Re: Raising Cane's Restaurant SWC of St Joseph and Coors Site Plan

DRAINAGE AND TRANSPORTATION INFORMATION SHEET (REV 6/2018)

MEMORANDUM

Subject: Raising Cane's Restaurant SWC of St. Joseph and Coors Site Plan

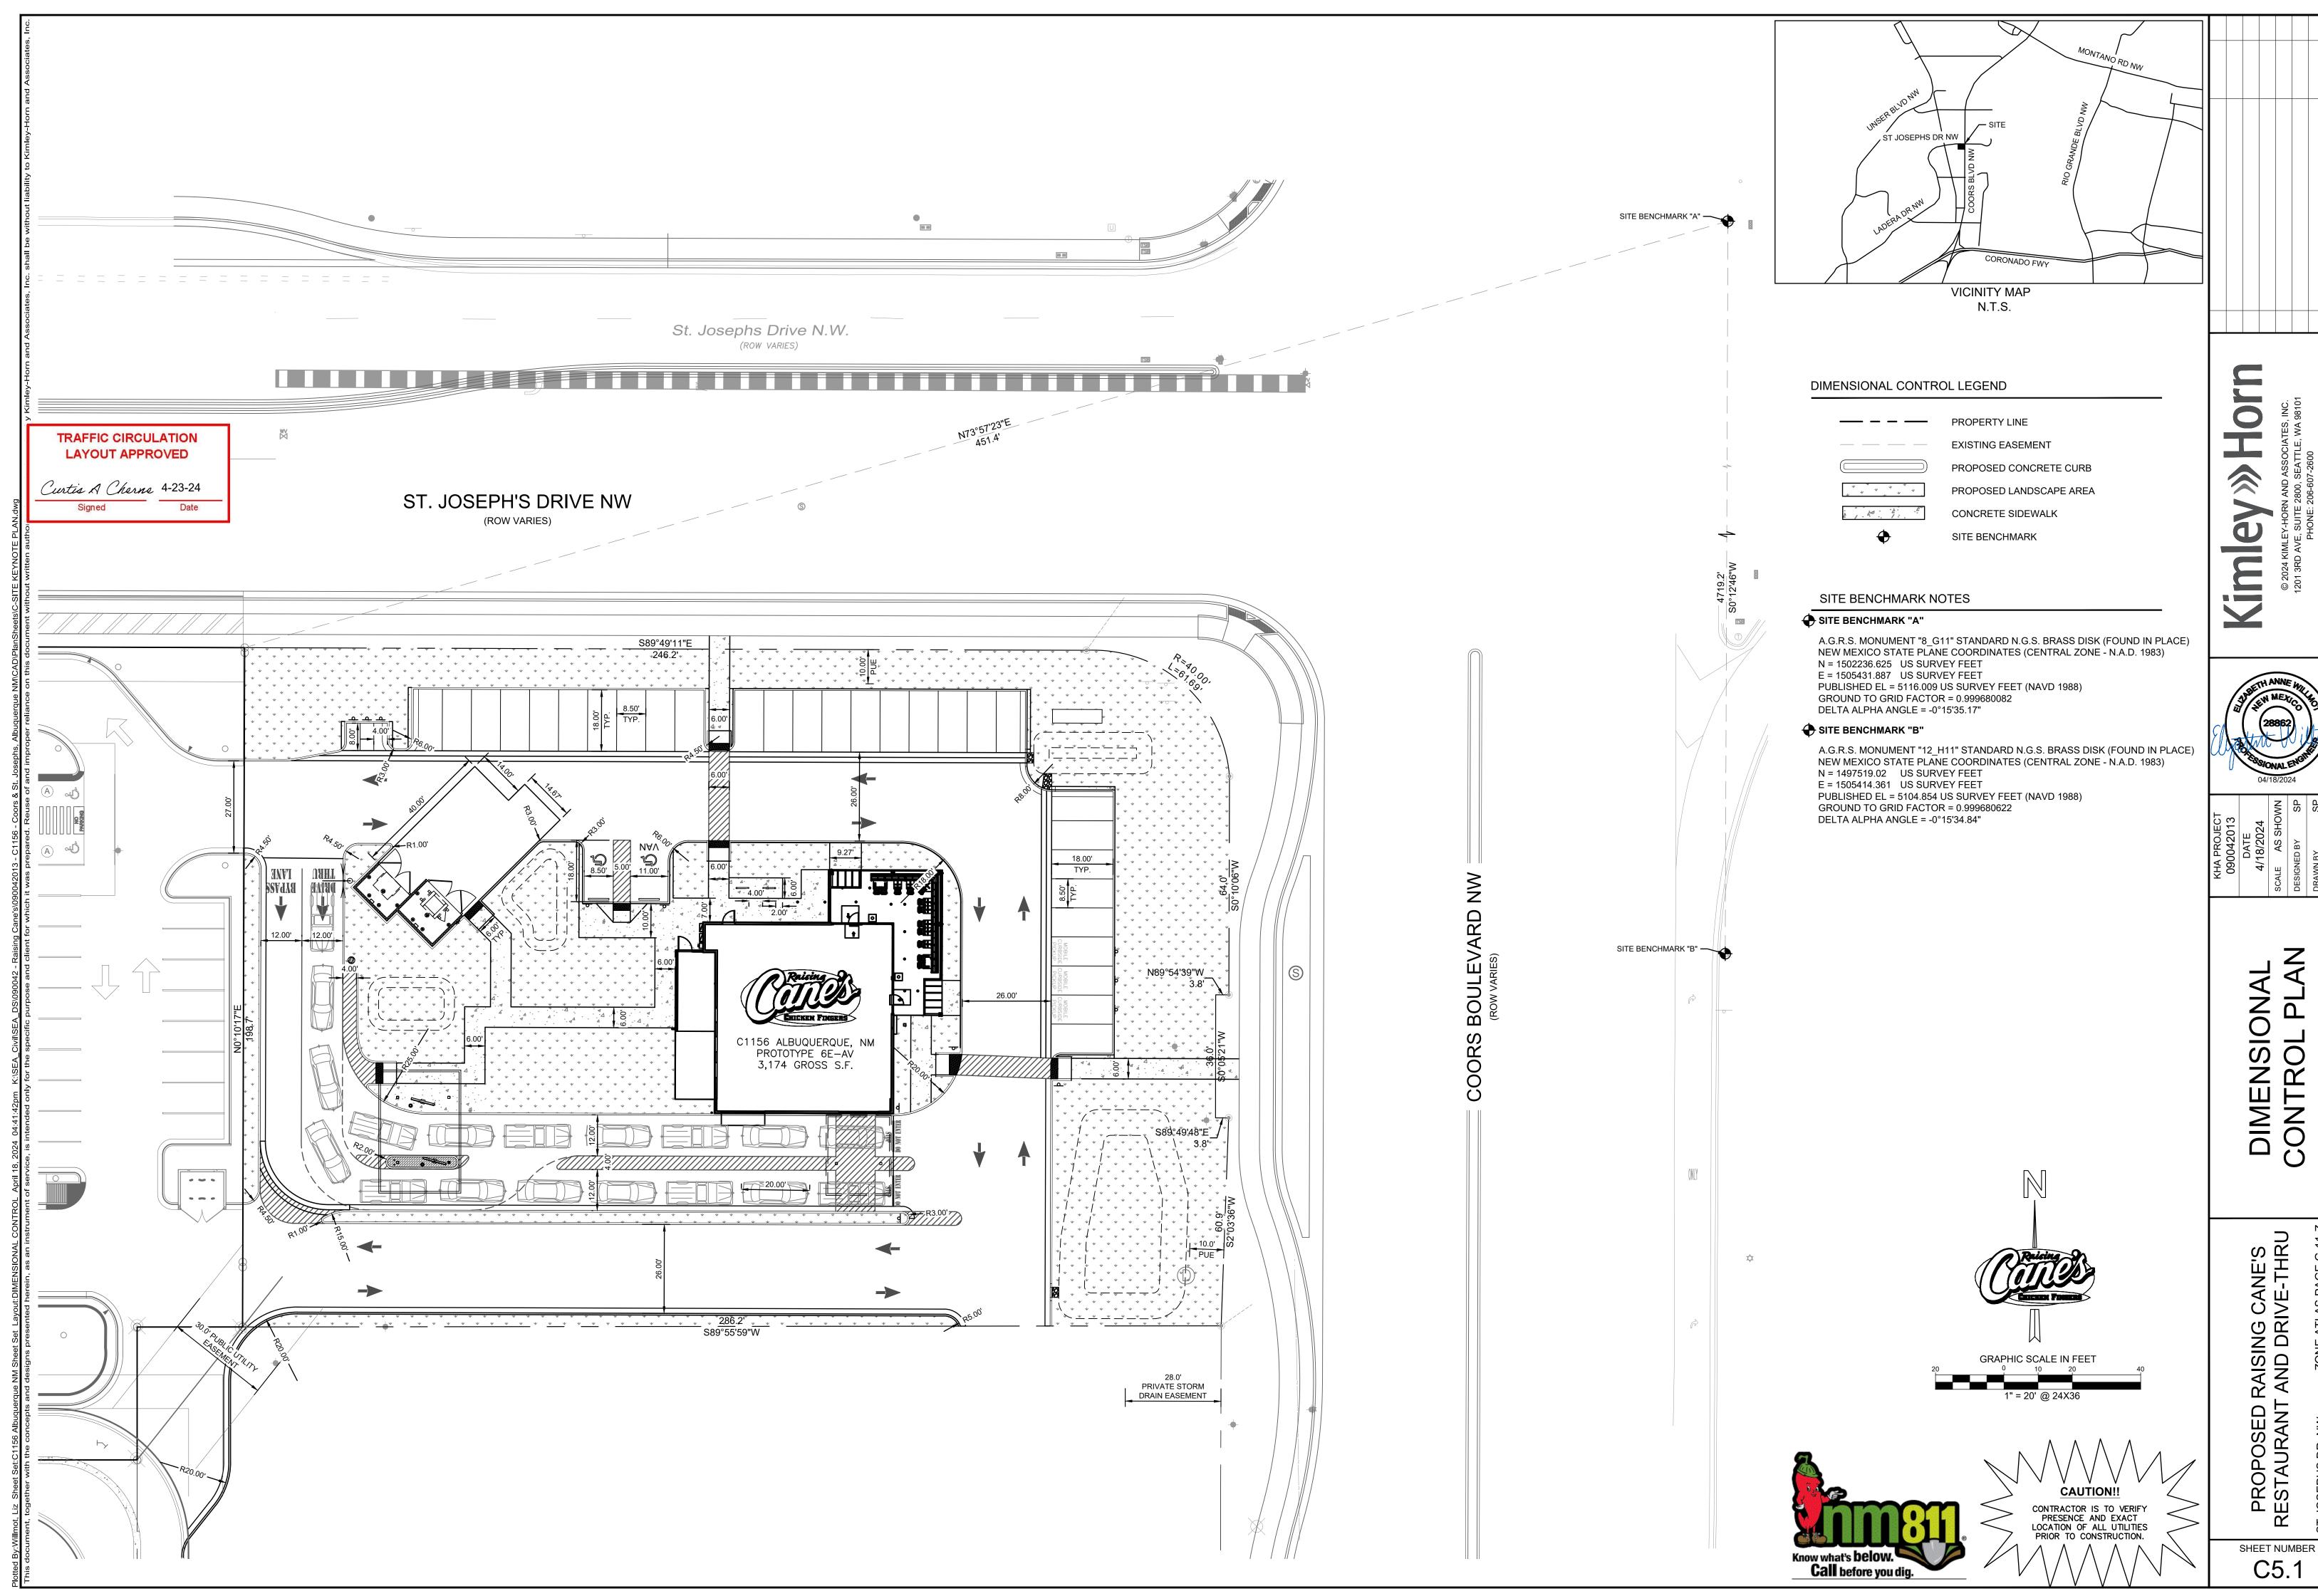
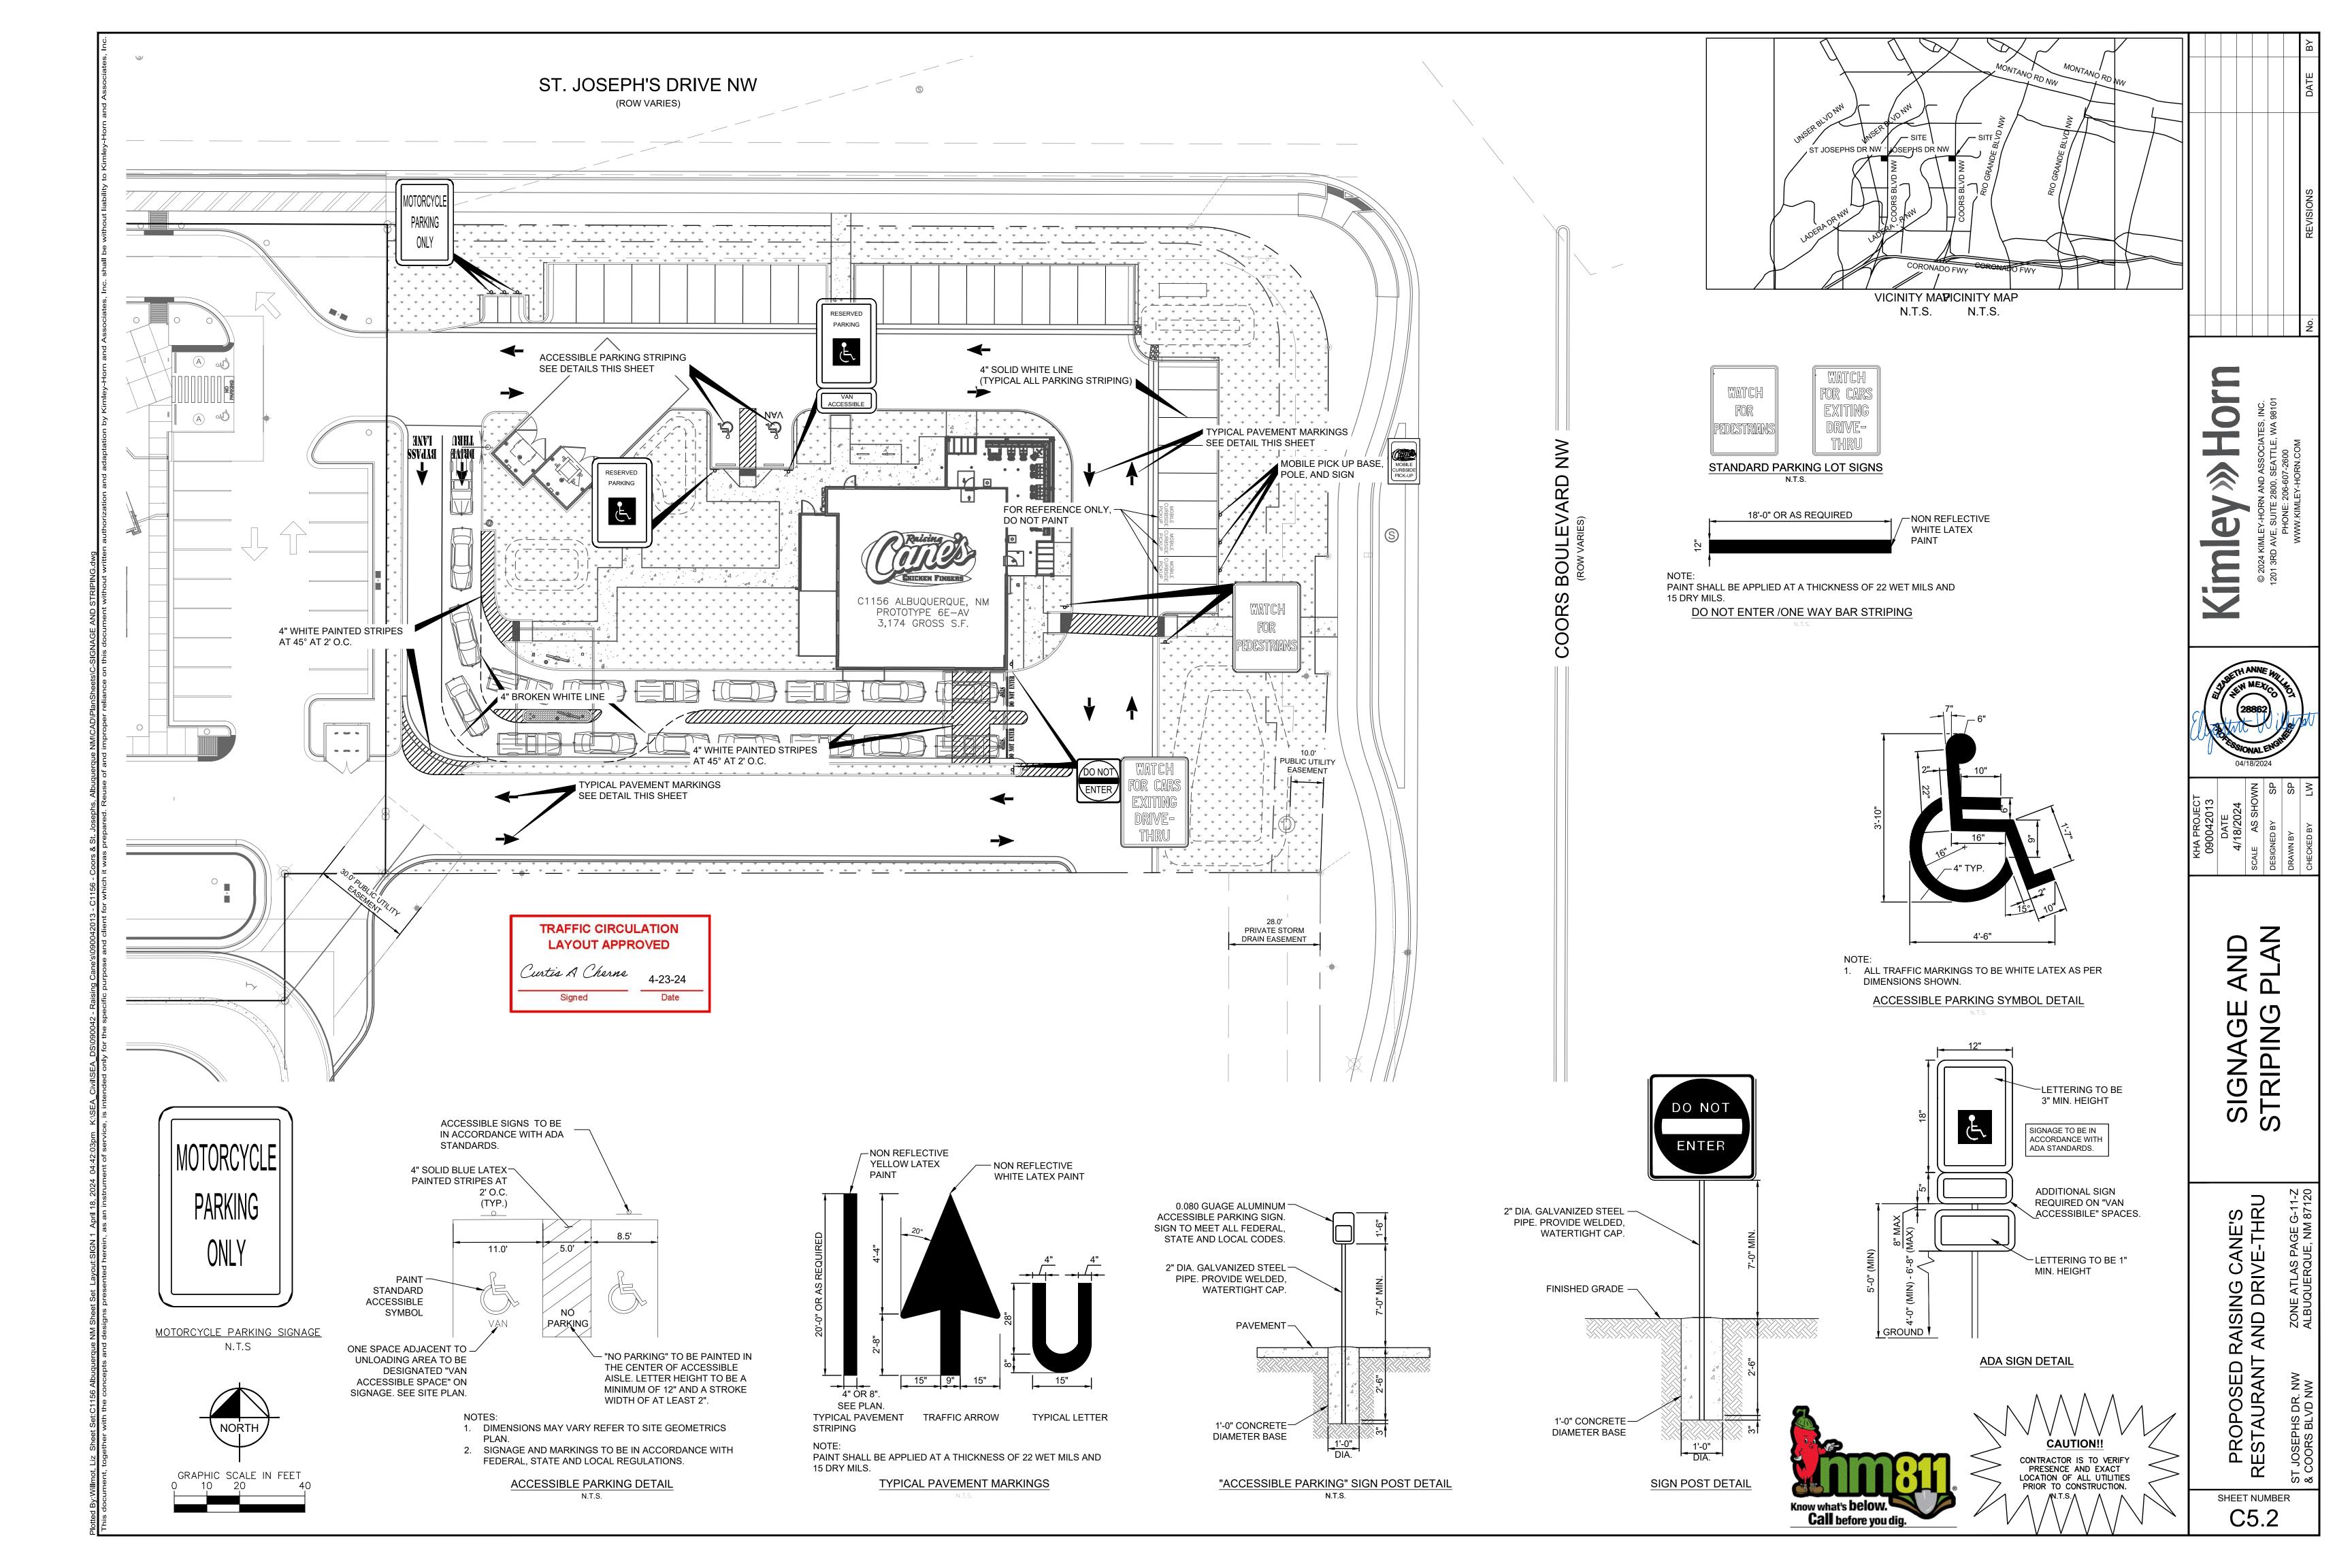
The entrance/exit at the private circulation road appears to have vehicles entering and exiting from three businesses with the Raising Cane's entering/exiting on a 45 degree angle at a 90 degree bend in the road. It is not clear how this intersection will function. The 2024 02 06 Oxbow Composite Plan Model (1)-Developer.pdf shows a better intersection as the Lot 6 entrance is 100 feet or more south of the 90 degree bend. This issue was discussed with Sydney (sp?) at Kimley Horn and we discussed showing the curb line across Lot 6 per the 2024 02 06 Oxbow Composite Plan Model (1)-Developer.pdf.

If this project is constructed before the bank to the west, a minimum of 24' wide asphalt will need to be constructed from the site out to the internal circulation road.

It appears you are proposing $\frac{1}{2}$ or so of a landscape area along the southern boundary. The 2024 02 06 Oxbow Composite Plan Model (1)-Developer.pdf shows parking spaces in this location. Please coordinate with the project on Lot 6 or the Developer to figure out what is to be built in this area.

Comment 4: Please revise the Parking/Site Data table to coincide with local and state regulations:

- a. Required parking is 17 spaces
- b. Required accessible is 2 spaces, one Van space (add the van space)
- c. Required Motorcycle is 1 space
- d. Required bicycle is 3 spaces
- e. There is no parking requirement for the drive-thru.

Comment 5: Provide a detail/keyed note for the bicycle racks. Contractors regularly install racks that don't meet City code. The inverted-U style meet our code as an example. Please let me know if you like more information on rack requirements.

Comment 6: The drive-thru lanes are to be a minimum of 12' wide. The minimum inside diameter radius is required to be 25 feet. Provide the three radii at the bend in the drive-thru. The radii can be reduced to 15', if the lanes are 14' wide.

The minimum stacking requirement is 12 cars at 20' each. It appears the stacking is 10 cars in the drive-thru lane. The length of a car is not provided. It appears the bypass lane is a drive-thru lane due to the location of the order board. How does the bypass lane function?

Comment 8: The broken white lines in the drive-thru and stacking lanes may be confusing to drivers,

but if can show you have stacking for 12 cars at 20' each, it meets out regs.

Comment 9: Please add a note "Broken or cracked sidewalk in the ROW is to be replaced".

Comment 10: Accessible aisle stripes should be blue rather than white.

Comment 11: The accessible aisle detail has the non-van space as 9.0' wide, whereas the site plan

Comment 12: The arrow on the concrete (dumpster pad) should be black rather than white so it is

The entrance/exit at the private circulation road has been revised to remove the additional driveway stub on the east side to lot 6. What is currently shown better aligns with the Oxbow Composite Plan Model.

Comment noted. This condition has been relayed to Raising Cane's for awareness and is recognized as a condition of occupancy.

At this time, it is Raising Cane's understanding that the future layout of Lot 6 is not yet determined. The proposed curb line on the south side lines up with the current composite plan for

potential parking addition by others. Raising Cane's will continue to coordinate with the overall developer regarding site layout.

Response: The Parking/Site Data table has been revised accordingly.

Response: Keynote T on sheet C5.0 has been updated to read "proposed inverted-U style bike rack."

Response: The drive-thru lanes have been revised to be 12' wide. The radius at the bend in the drive-thru has been revised to be 25' and has been annotated accordingly.

The second drive-thru lane after the bend will be used daily. Queuing cars can select either drive-thru lane at the bend to order and pick up their food. The vehicles shown on sheet C5.0 using the single drive-thru lane at the entrance and then breaking into two lanes are considered to be Raising Cane's standard queuing operations that will be utilized daily. The total number of vehicles able to successfully queue is 18.

A dimension has been added to a vehicle block immediately south of the building, 20' per vehicle is utilized for design.

The bypass lane can be used by customers if 18 cars have already queued and will function as a second full-length drivethru lane. The curb cut at the southeast corner allows customers to exit the drive-thru lane before ordering if they choose.

Response: The broken white lines are Raising Cane's operational standard

and are utilized if employees need to direct traffic towards one

menu board or one pick-up aisle during low volume times.

Response: Site note #8 has been added.

Response: The arrows have been shifted to the west so they are not painted

across two different pavement types.
